MANDATORY SERVICE BULLETIN

NUMBER: SB11-08
REVISION: 00
DATE: 06/24/2011

SUBJECT: SPAR PASS-THRU HOLE AND TAILCONE MODIFICATION

KODIAK 100 Series Aircraft Serial Numbers: 100-0001 through 100-0045.

Figure 1-1: Spar Pass-Thru Hole Modification

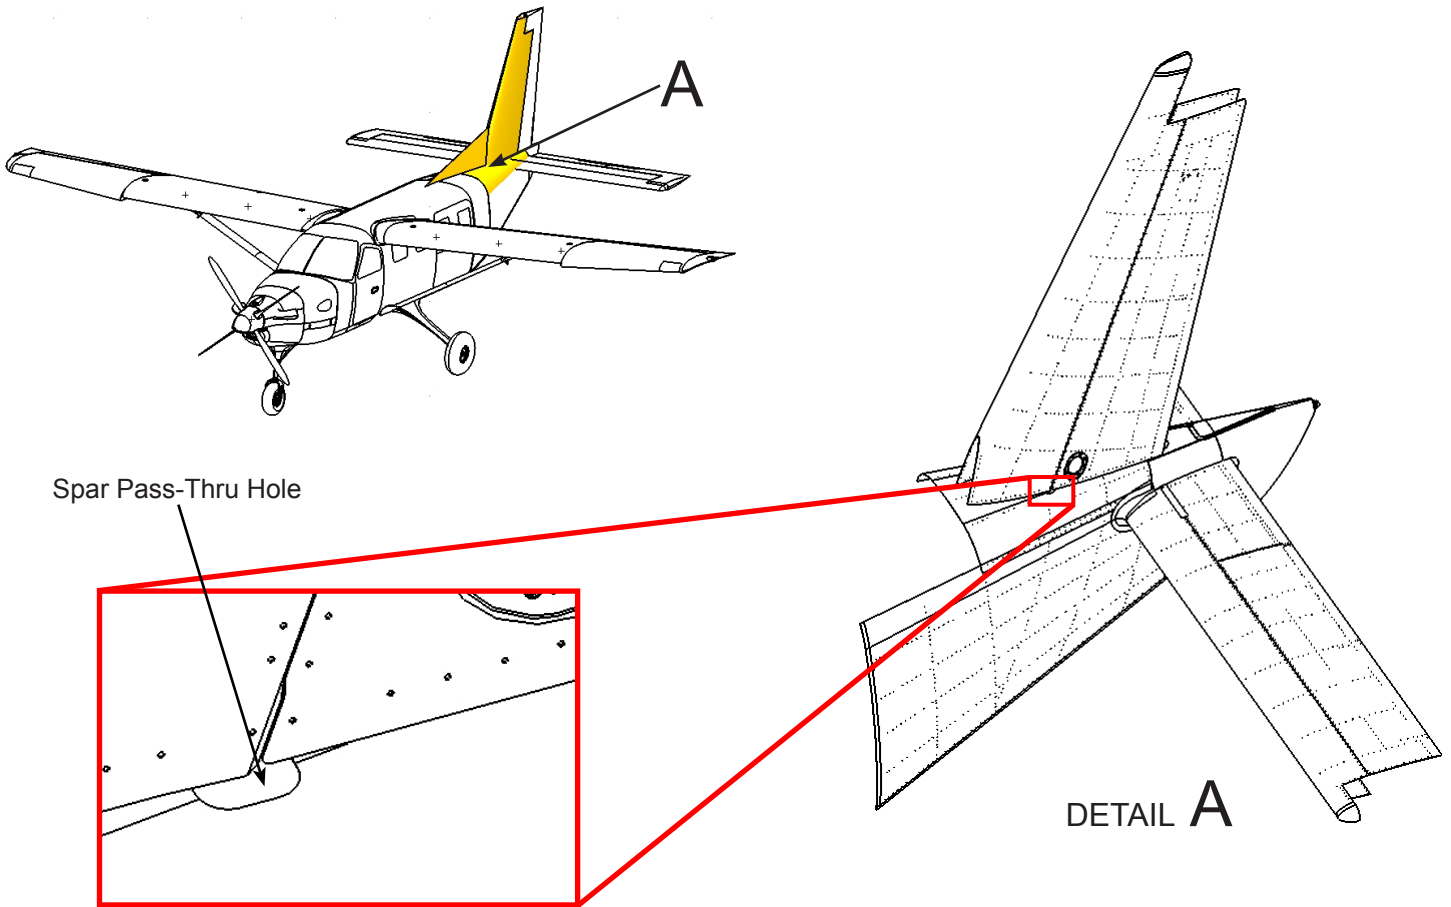
It has been determined that the mount design of the vertical tail leaves two uncovered areas in the top of the fuselage that allows fluid entry into the area AFT of the rear interior bulkhead. This fluid does not adequately drain, and has a potential to negatively affect some of the electronics.

Quest is mandating the installation of a sealant over the area indicated in **Figure 1-1**, as well as the installation of two (2) drain grommets on the underside of the tailcone.

1. Remove the AFT bulkhead from the aircraft as shown in the KODIAK 100 Maintenance Manual (P/N **490770**).
2. Clean the interior and exterior surfaces around the spar pass-thru holes shown in **Figure 1-1** using a lint-free cloth and denatured alcohol or equivalent.
3. Apply masking tape to the inside surface of the aircraft skin covering the spar pass-thru holes shown in **Figure 1-1**.

1. Apply ProSeal® (P/N **P/S 890 B-2**) into the spar pass-thru holes shown in **Figure 1-1** on both sides of the aircraft. Ensure the sealant adheres around the perimeter of the holes and is faired to the upper surface of the aircraft skin with a 0.06" to 0.13" overlap over the edges of the hole.
2. Follow all manufacture's safety and cure time instructions.
3. Remove the masking tape applied to the inside surface of the aircraft skin.
4. Reinstall the AFT bulkhead into the aircraft as shown in the KODIAK 100 Maintenance Manual (P/N **490770**).

DETAIL B

Completed Sealant Installation

**NOTE:** Verify that the existing X1010 edge trim on the vertical stabilizer skin is adhered to the skin and in good condition.

**NOTE:** Sealant application should be mirrored on the right side of the aircraft.

Figure 1-2: Tailcone Modification

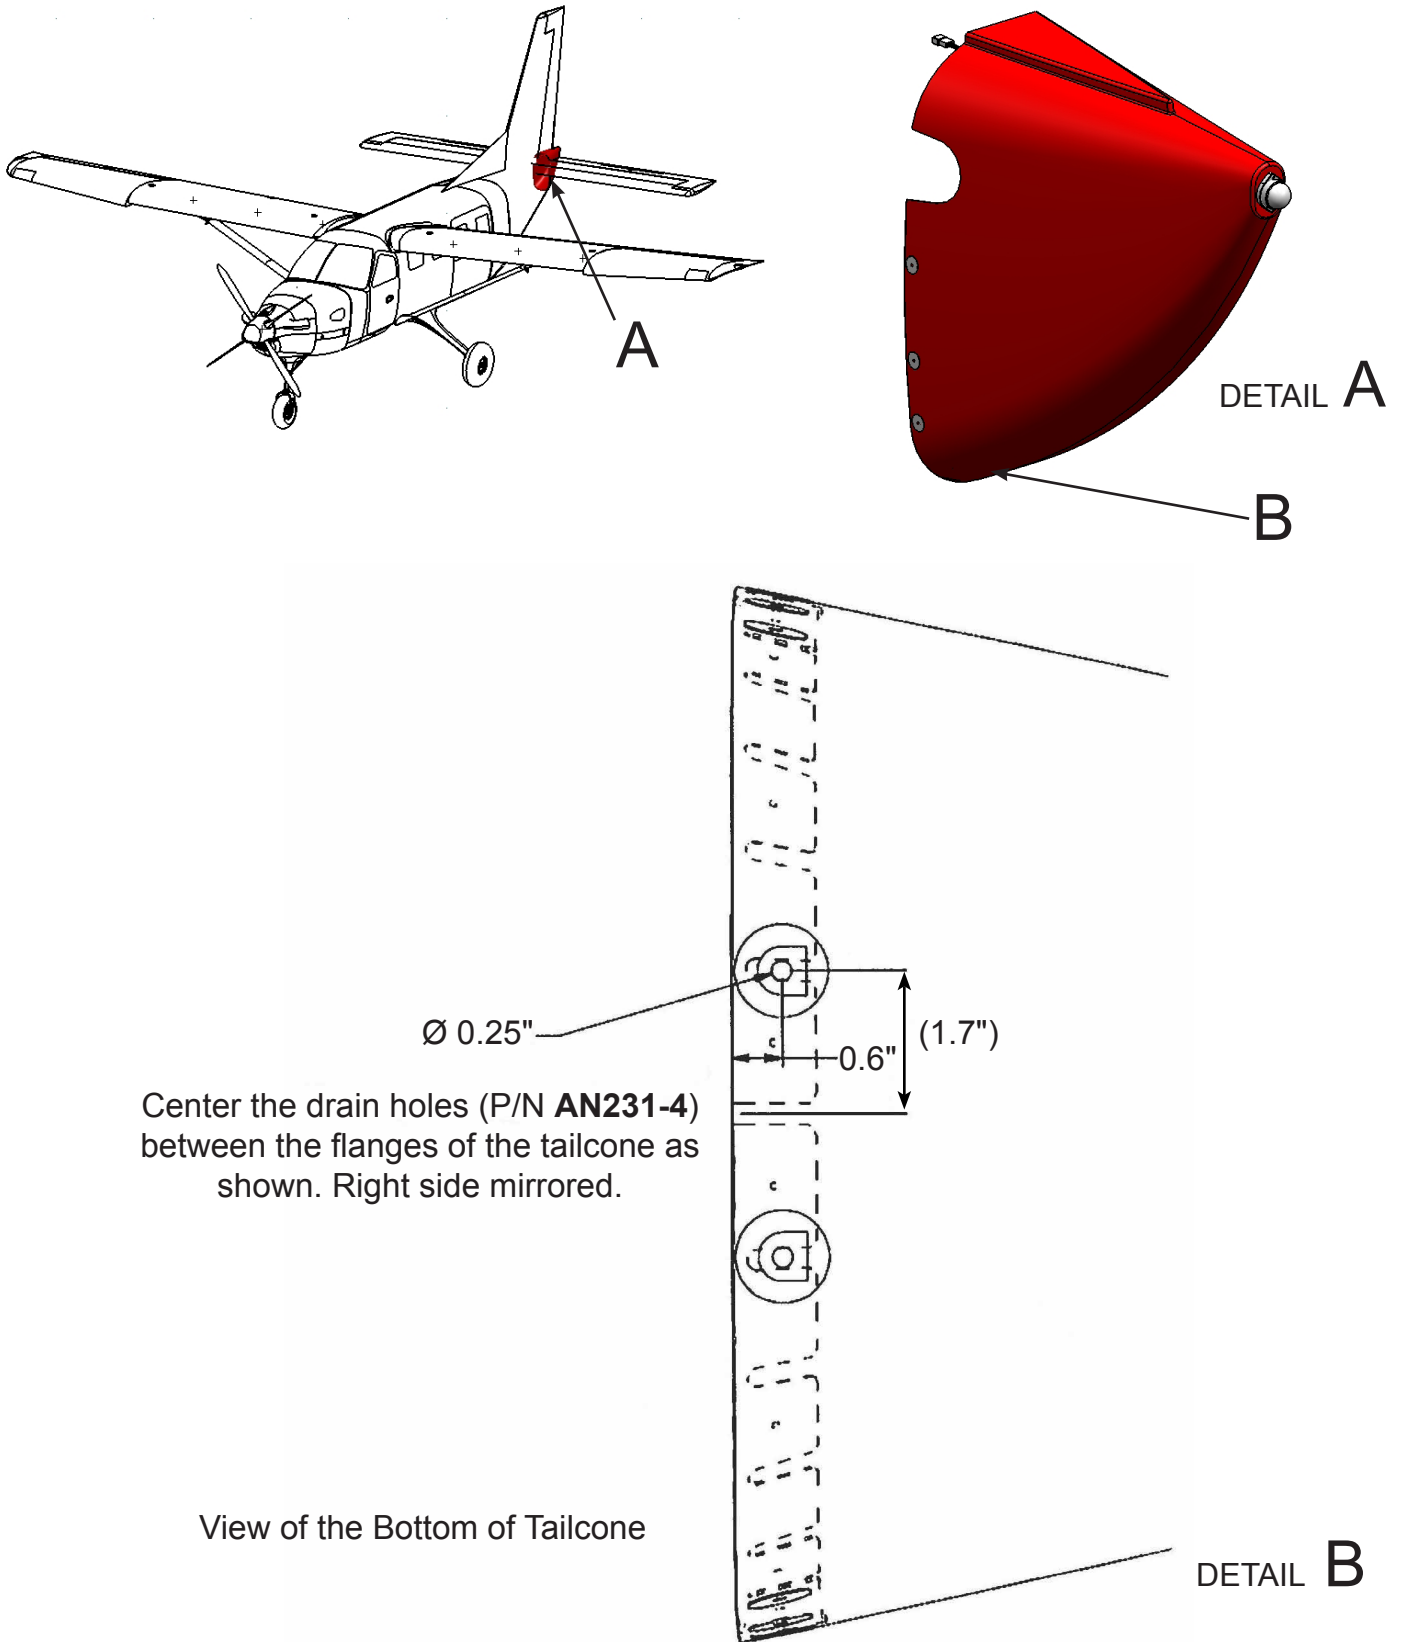
1. Remove the twenty eight (28) screws securing the tailcone (P/N **100-250-0097**) to the aft fuselage and remove the tailcone (P/N **100-250-0097**) from the aircraft.
2. Disconnect the electrical connection to the tailcone navigation light.
3. Mark and drill the drain holes as indicated in **Figure 1-2, Detail B**.
4. Apply Loctite® activator (P/N **7387**) to the bonding surfaces of the tailcone (P/N **100-250-0097**) and the two (2) drain grommets (P/N **AN231-4**).
5. Apply Loctite® adhesive (P/N **330**) and center the two (2) drain grommets (P/N **AN231-4**) over the two (2) drain holes with the exit port facing aft as shown in **Figure 1-2, Detail B**.
6. Follow manufacturer's safety and cure time instructions.
7. Position and secure the tailcone (P/N **100-250-0097**) using the twenty eight (28) screws and connect the navigation light.
